ARKANSAS STATE HIGHWAY AND TRANSPORTATION DEPARTMENT  
CONSTRUCTION PLANS FOR STATE HIGHWAY

ARKANSAS COUNTY AREA  
HEADQUARTERS  
(STUTTART) (S)

JOB 020512

4 INDEX OF SHEETS, GOV. SPECS., SUMMARY OF QUANTITIES, REVISIONS

DRAWING NO. **F-1**

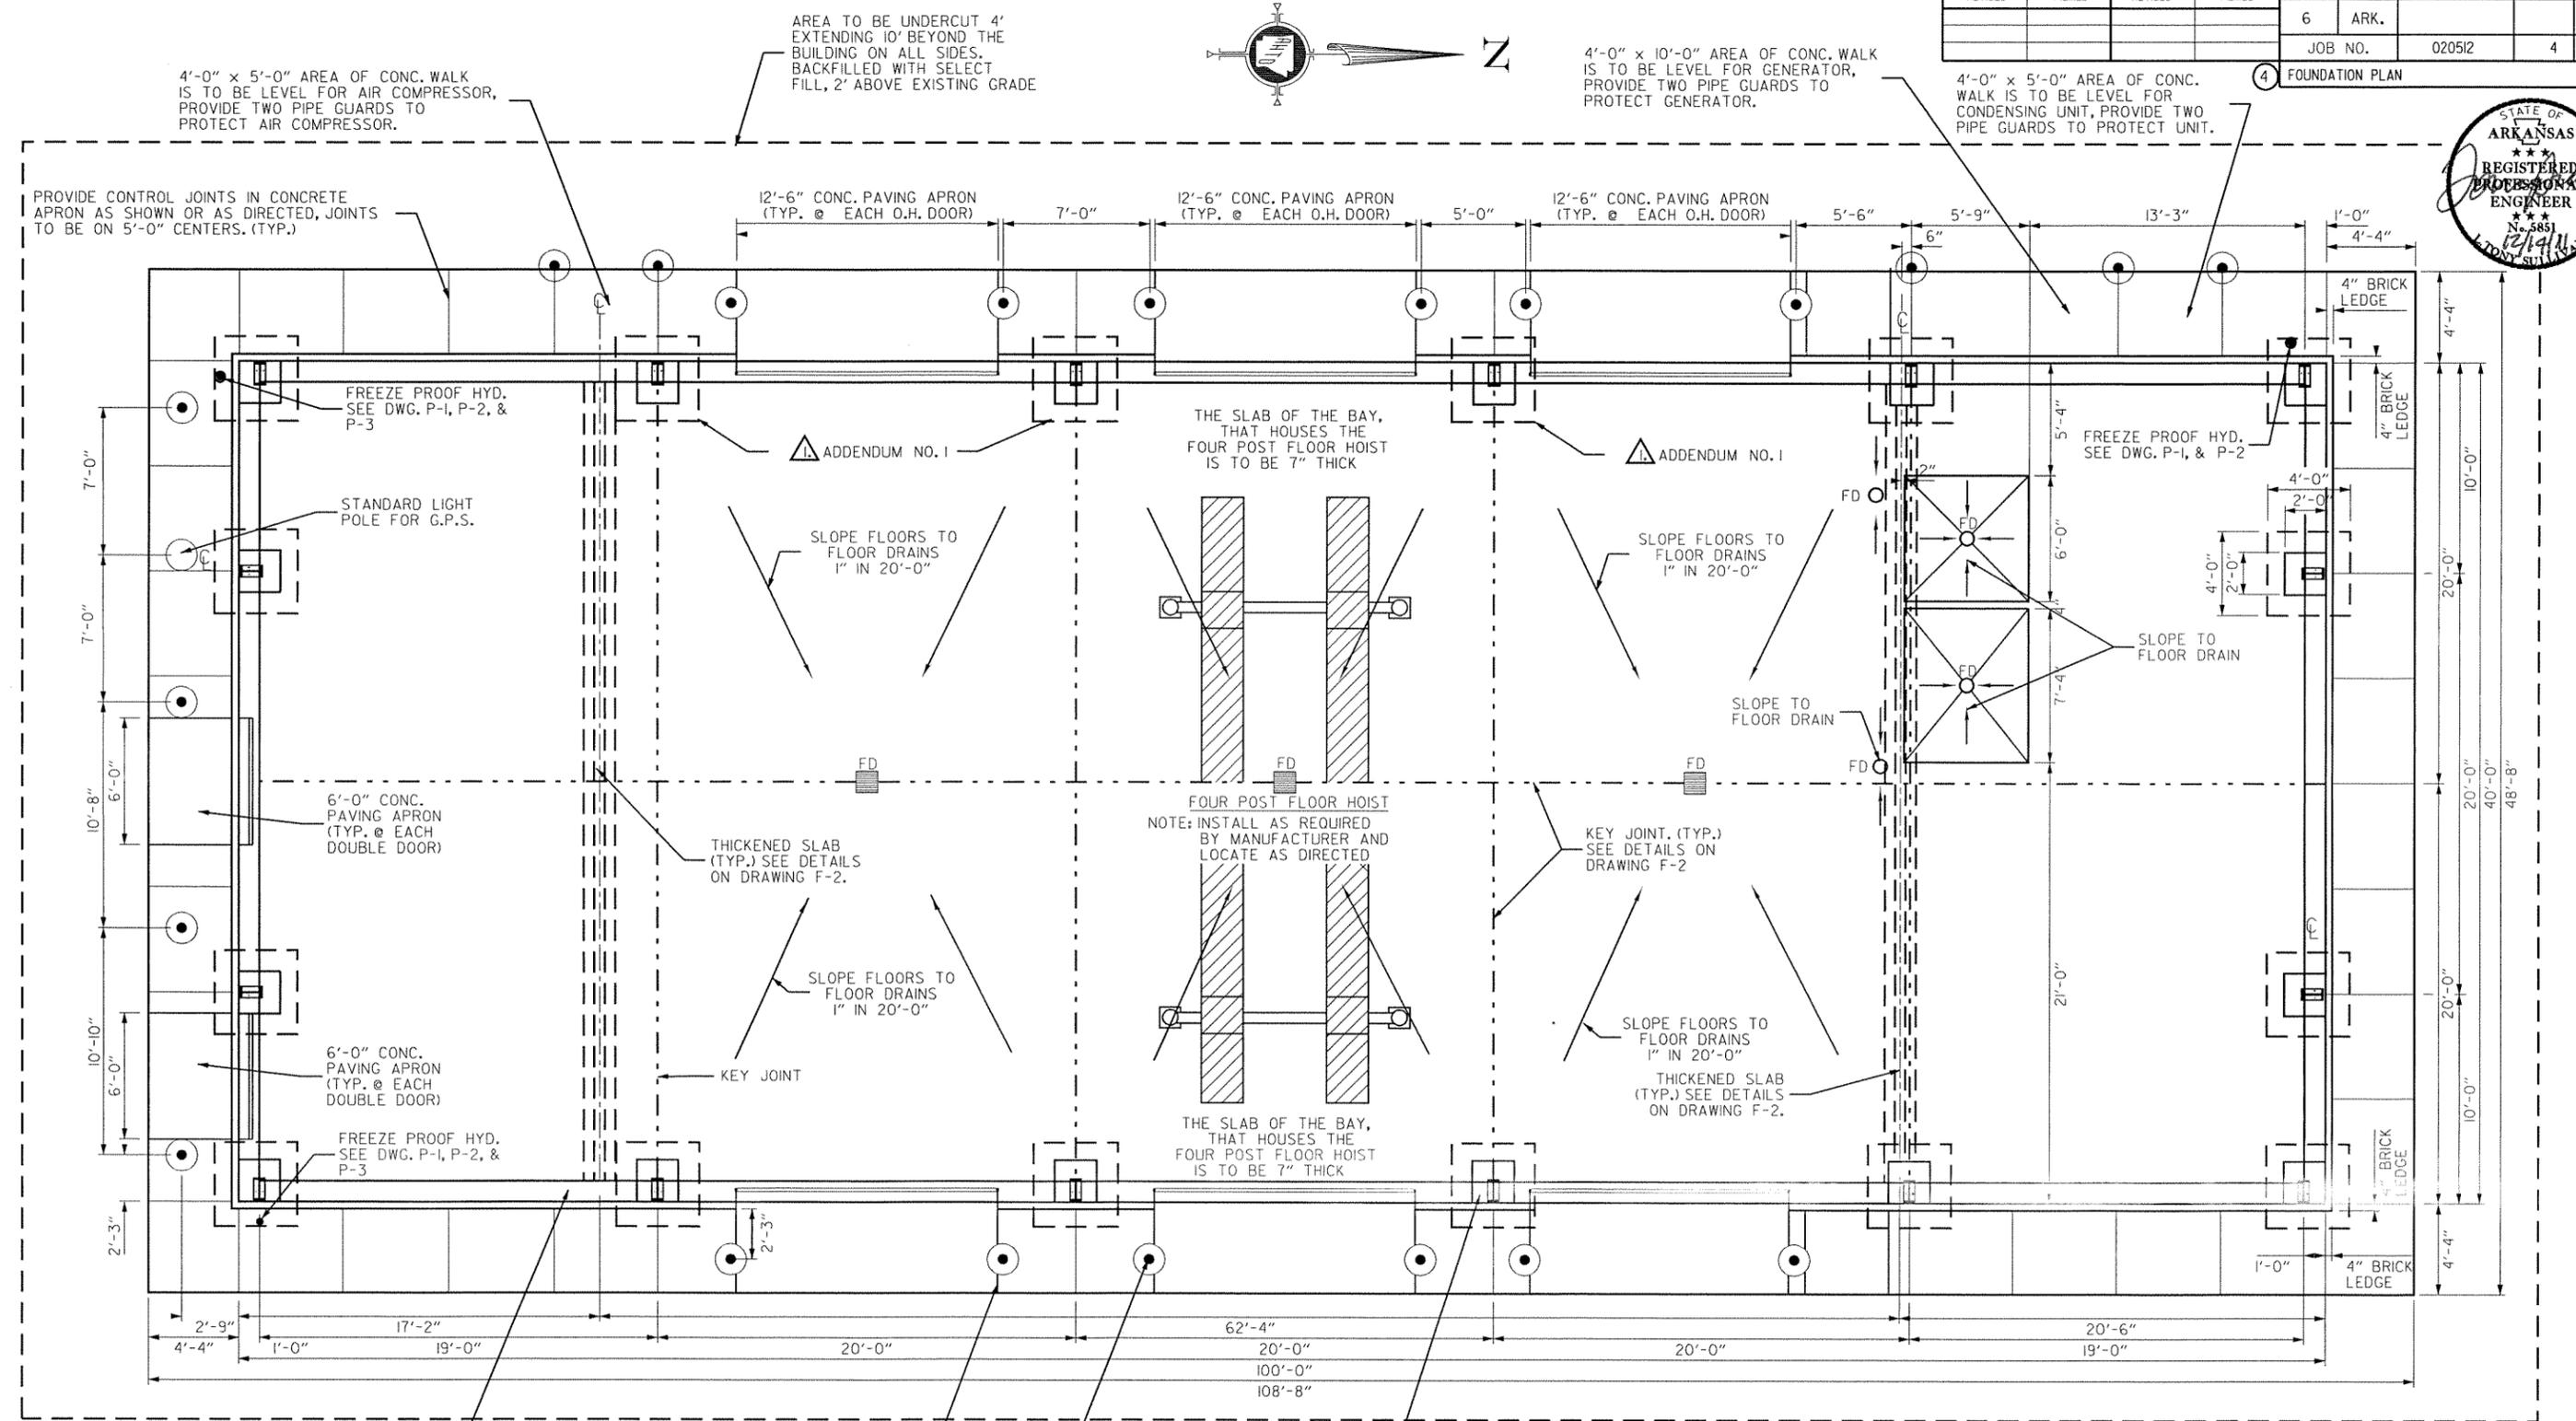
ADDENDUM NO. 1

THE SLAB OF THE BAY, THAT HOUSES THE FOUR POST FLOOR HOIST IS TO BE 7" THICK

ADDENDUM NO. 1

THE SLAB OF THE BAY, THAT HOUSES THE FOUR POST FLOOR HOIST IS TO BE 7" THICK
